CONTRACT ADDENDUM NO. 3

April 6, 2026

NOTICE TO ALL BIDDERS FOR THE: **Topeka & Shawnee County Public Library** Staff Spaces Renovations HTK Project No.: 2001.01-021

2 RCP - UPPER LEVEL ANNEX - BASE BID
1/8" = 1'-0"
NORTH

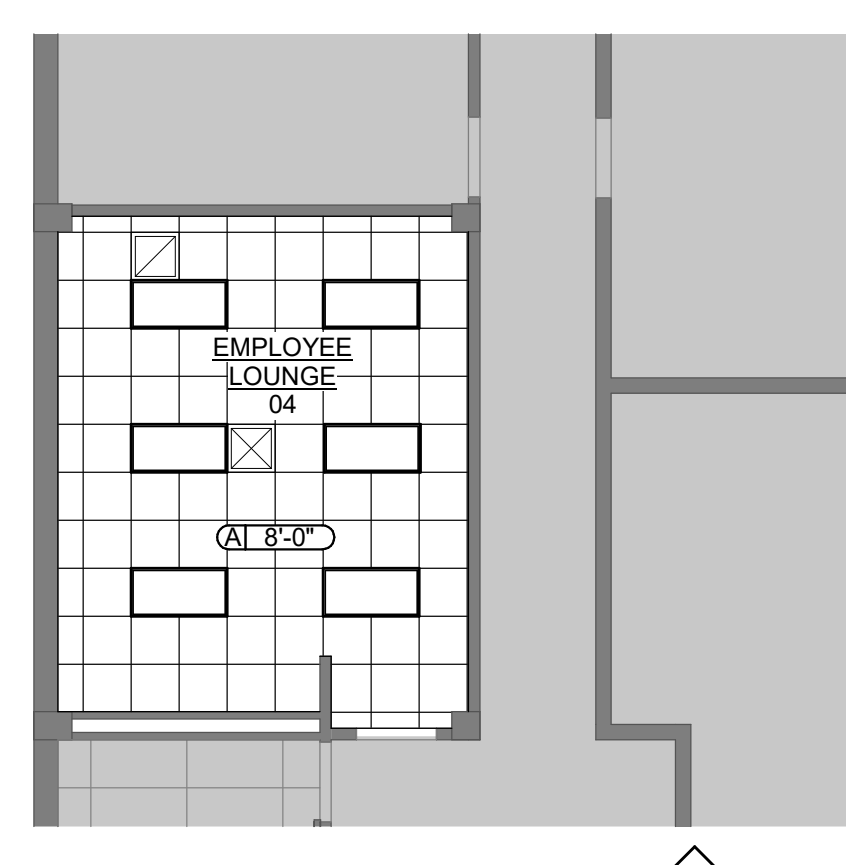
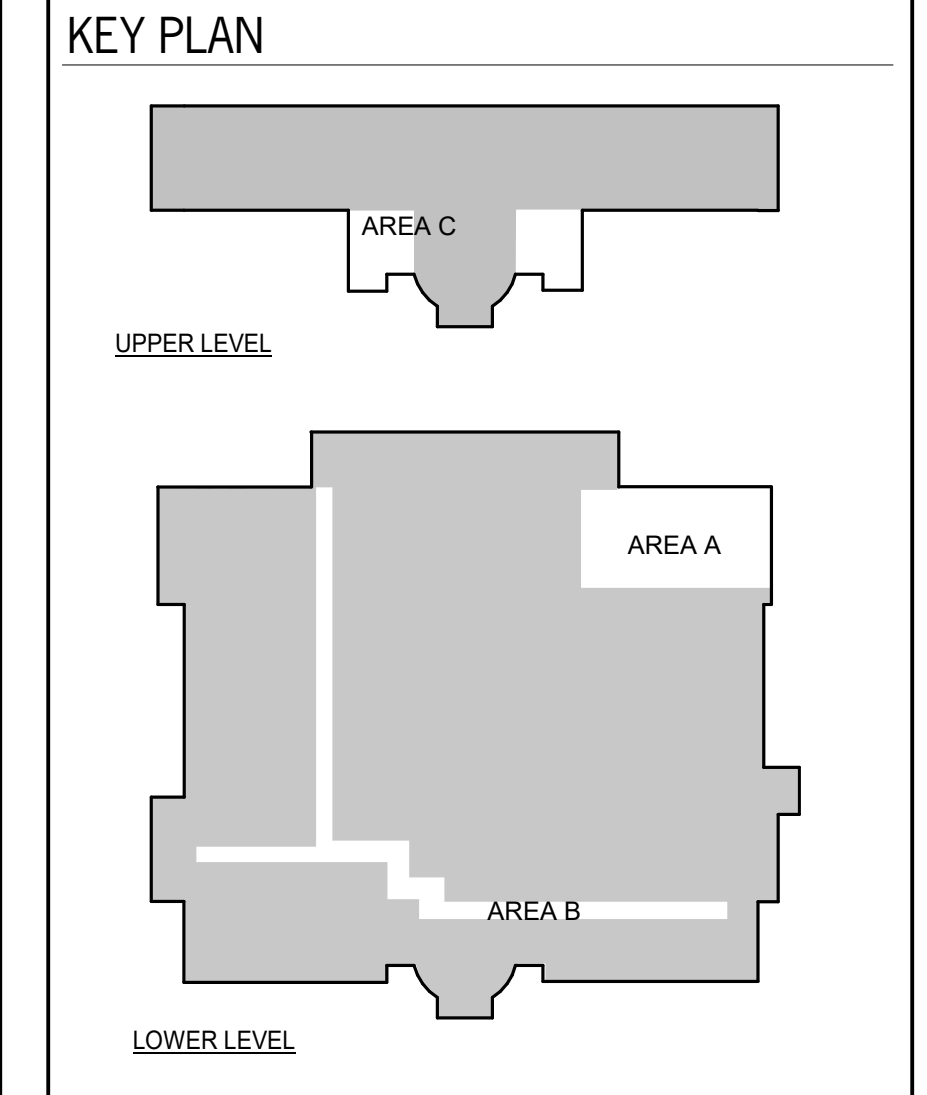
1. Add Plan Note 3 to existing ceiling tile and grid outside of Office 214.

3 DEMO PORTION OF EXISTING CLG TILE & GRID TO NEAREST FULL TILE. INSTALL NEW TILE & GRID AT DEMOED PORTION.

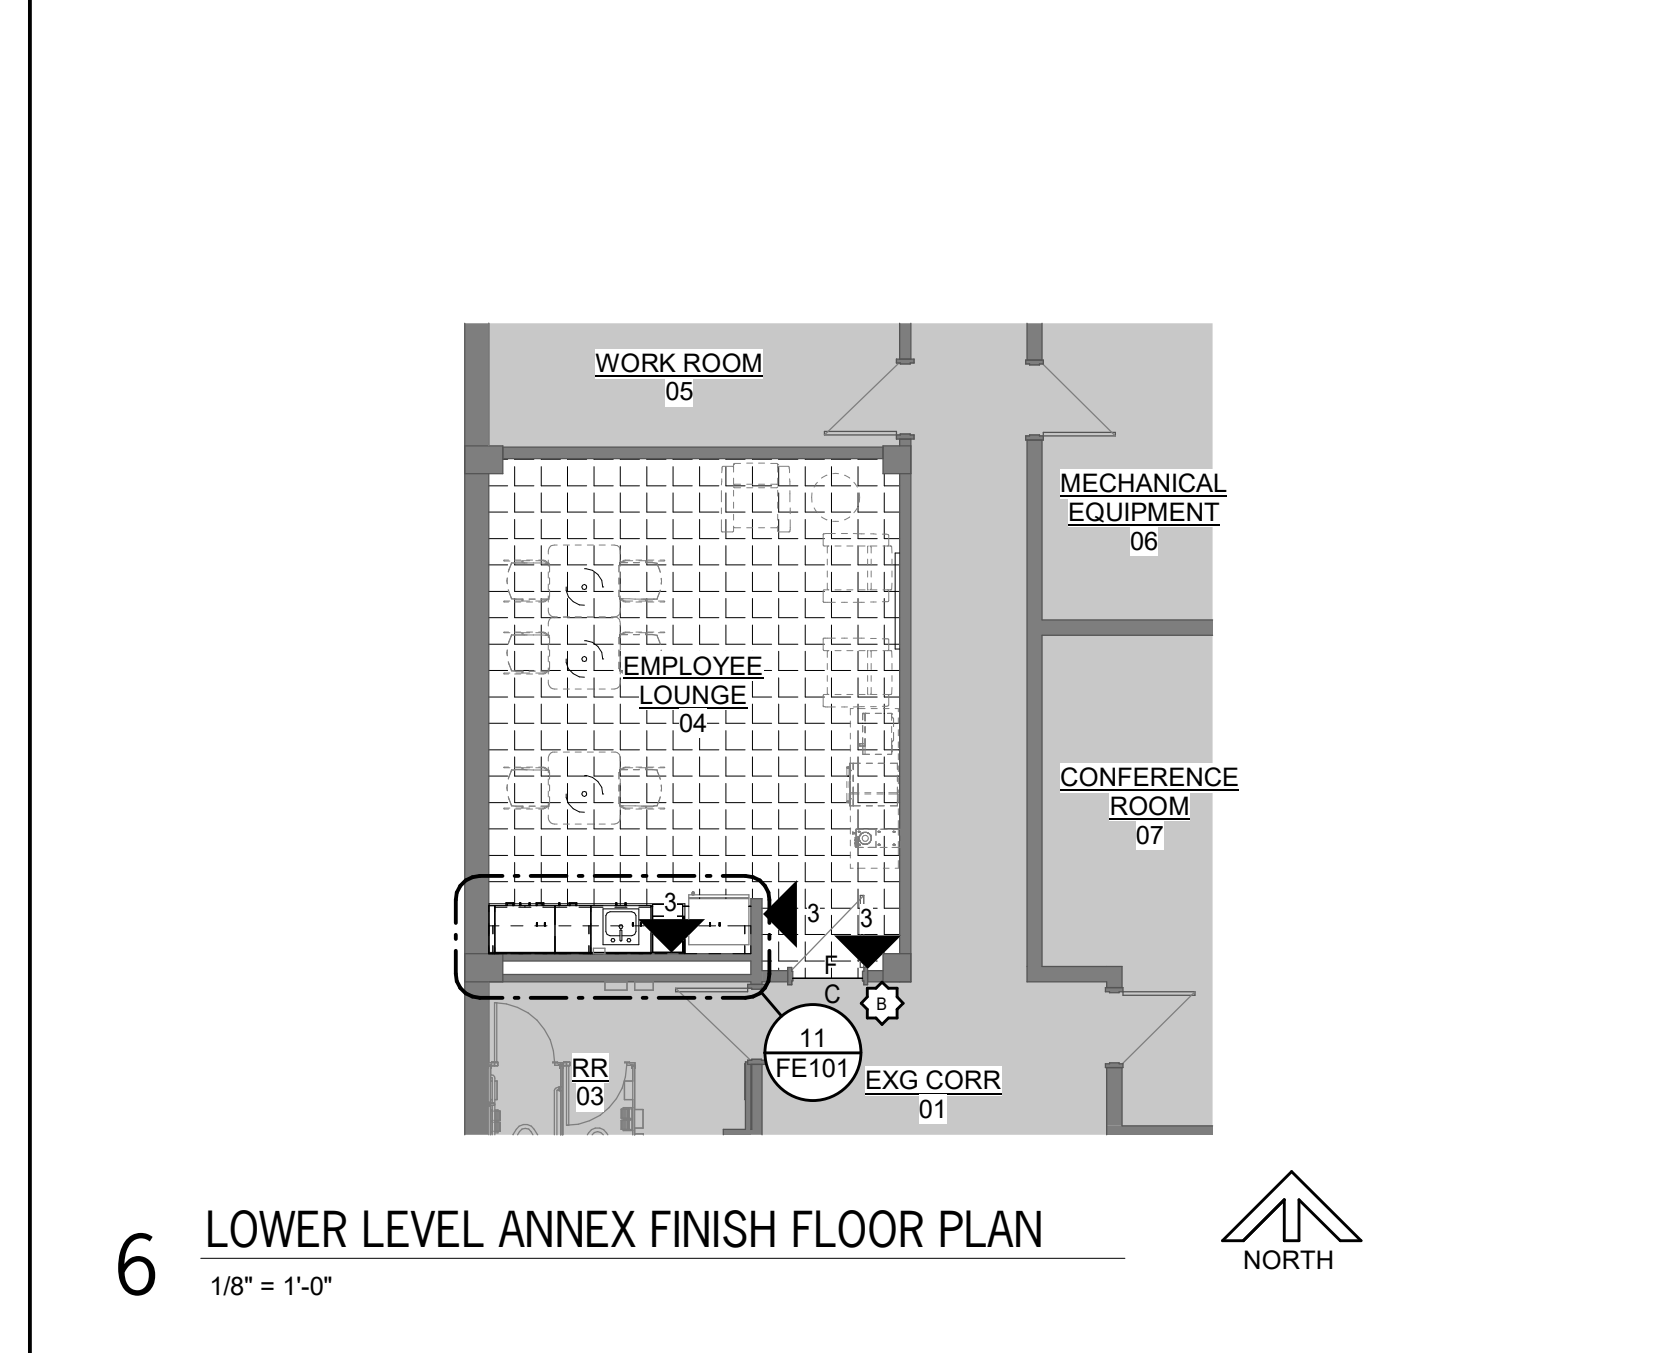
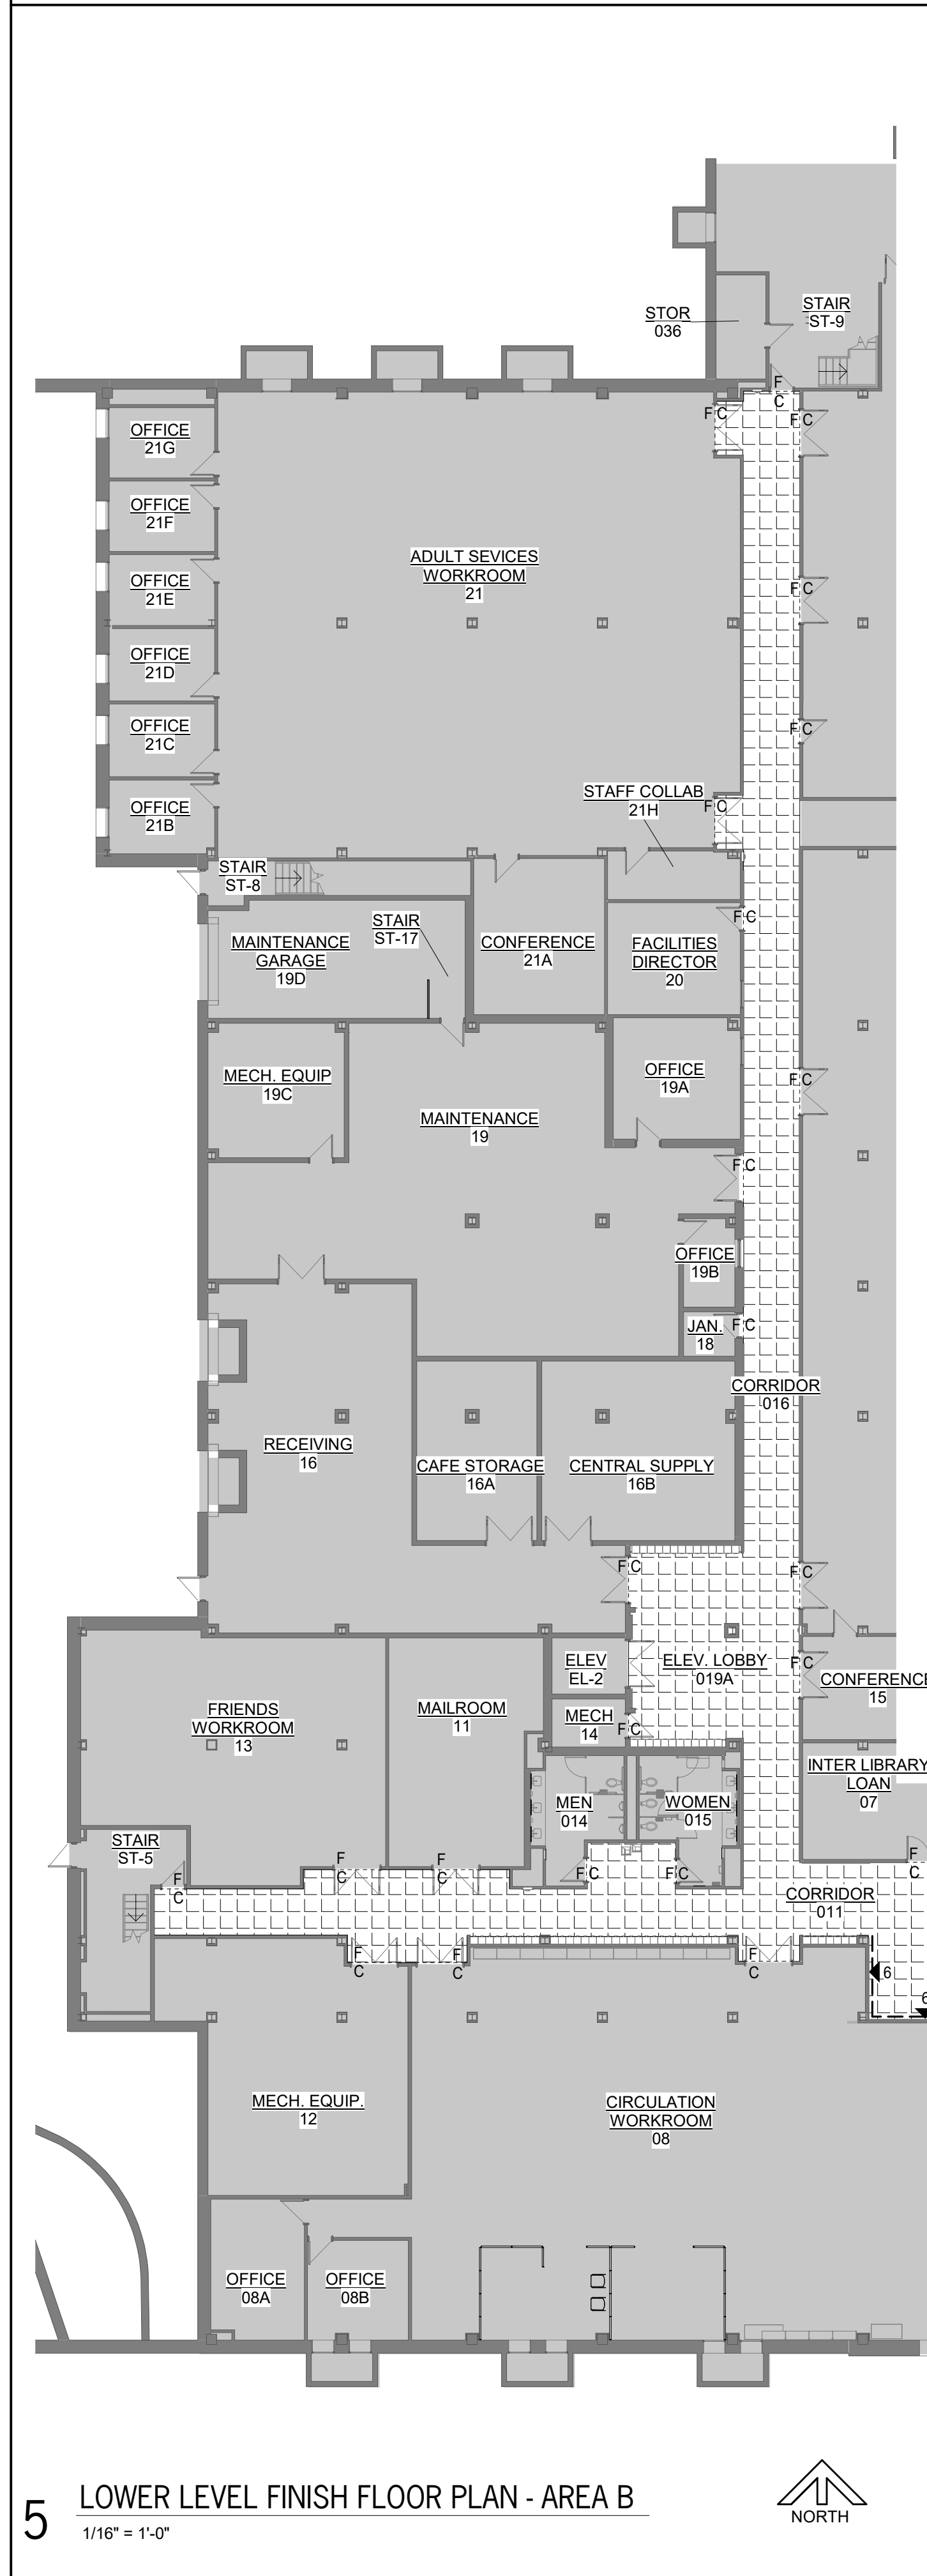
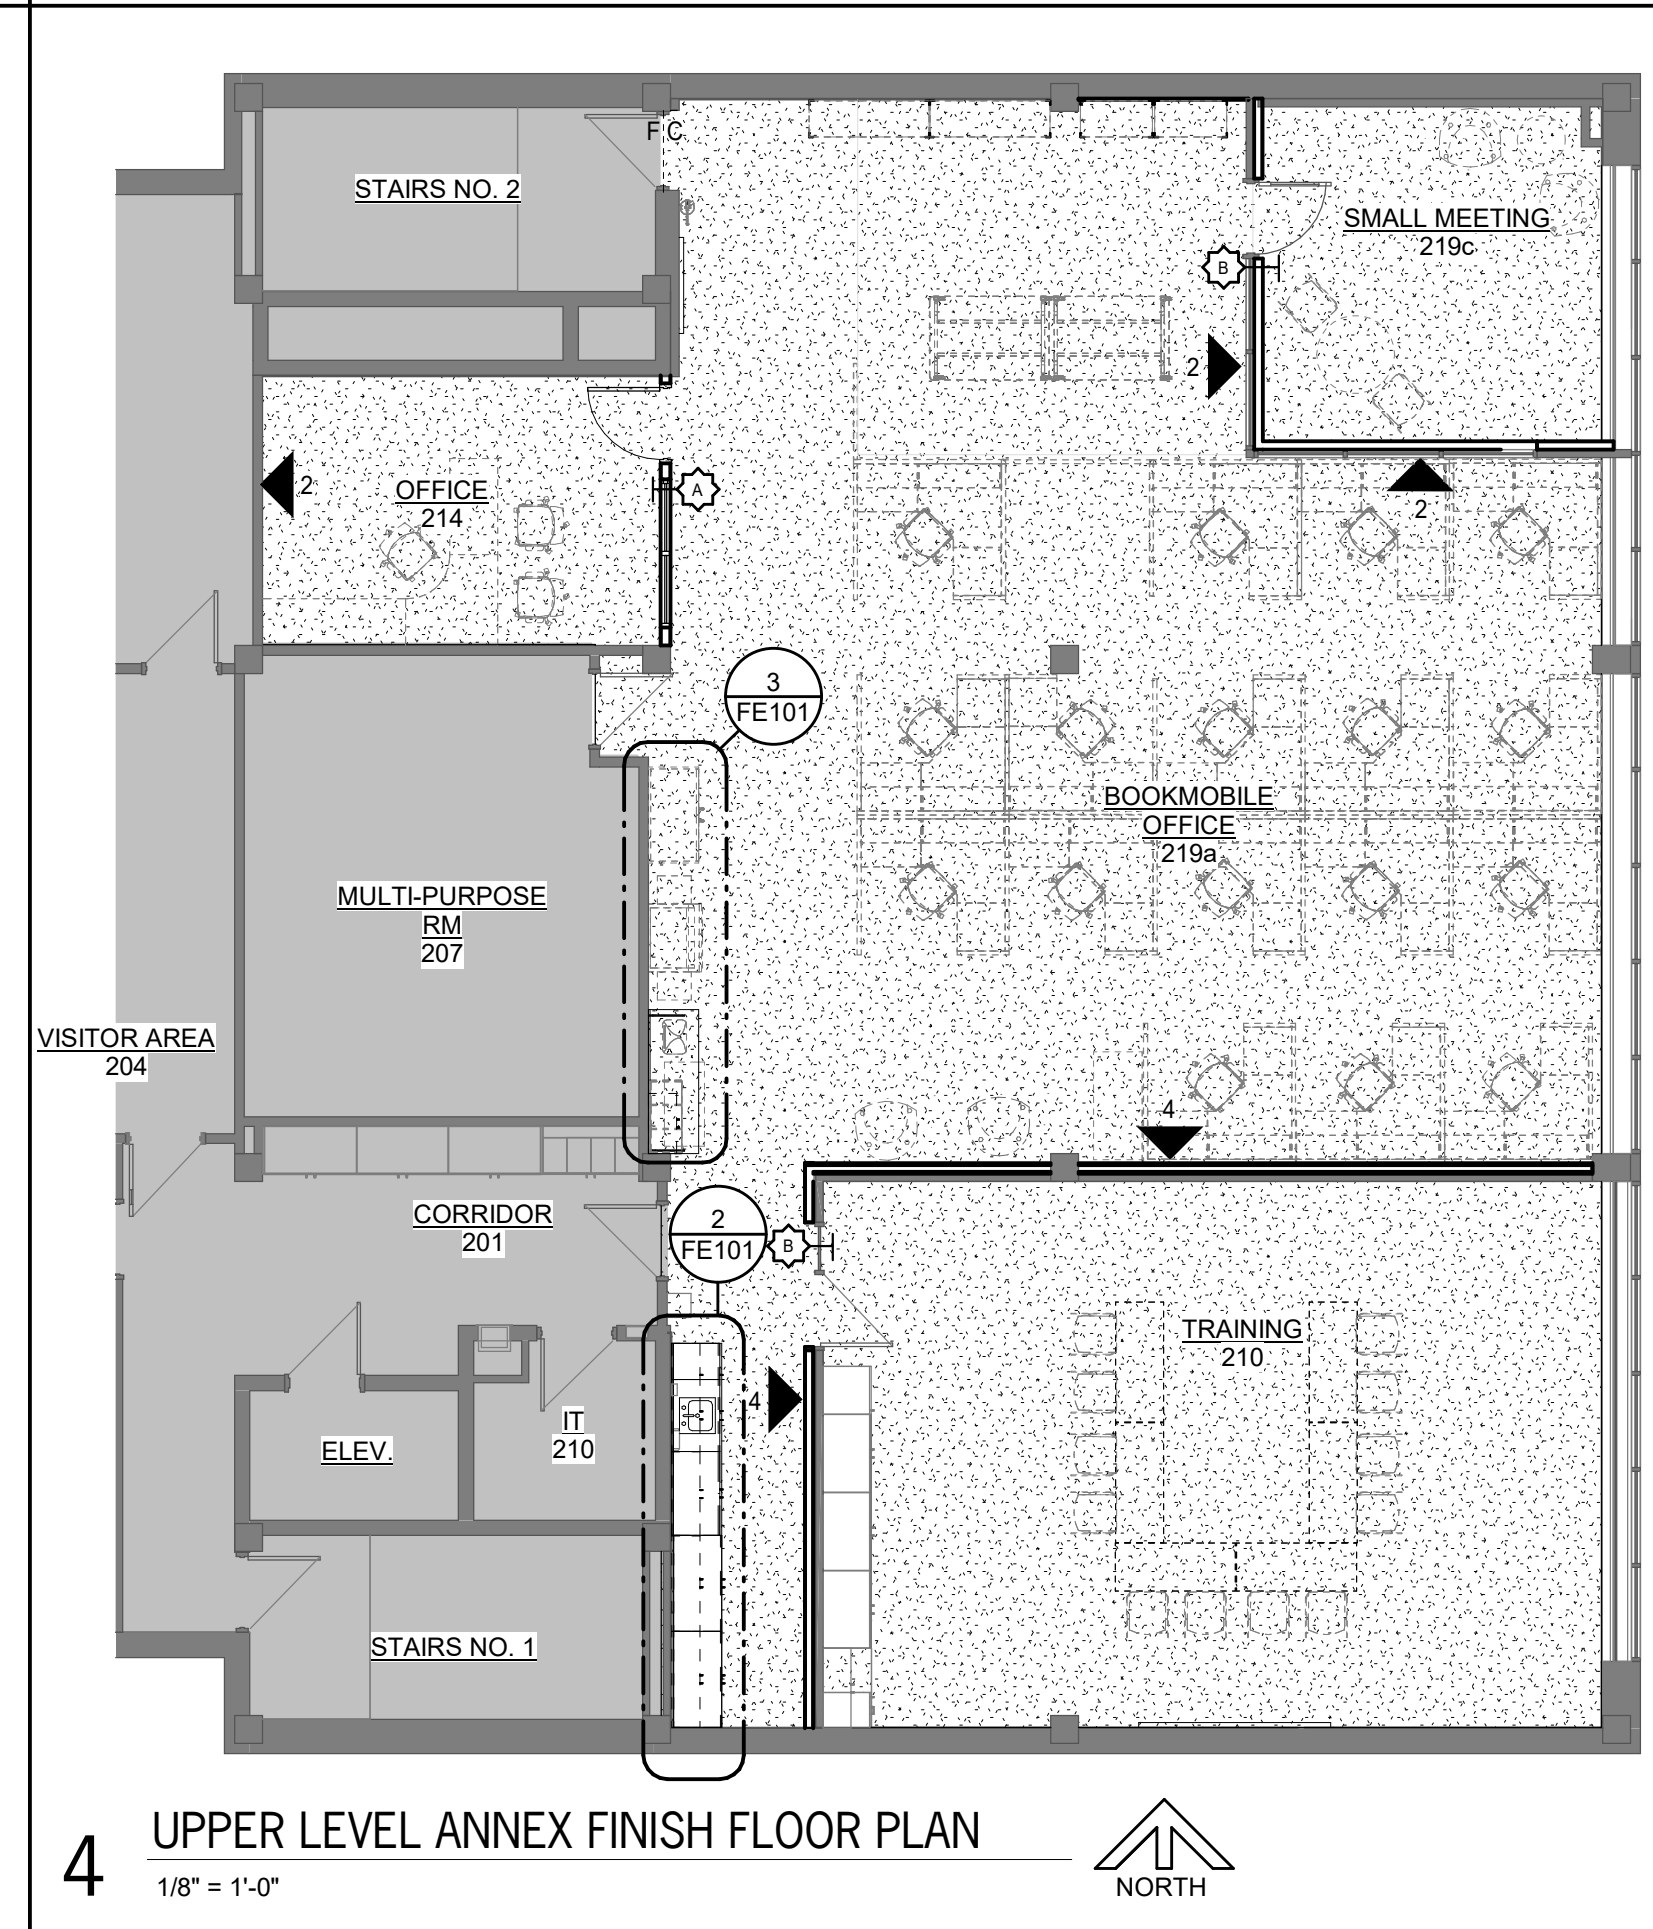
1. Provide Resilient Edge Guard between new Carpet Tile or LVT and Sealed Concrete as indicated in revised 2/A701.
2. Provide transition strips as shown on revised 1/A701.
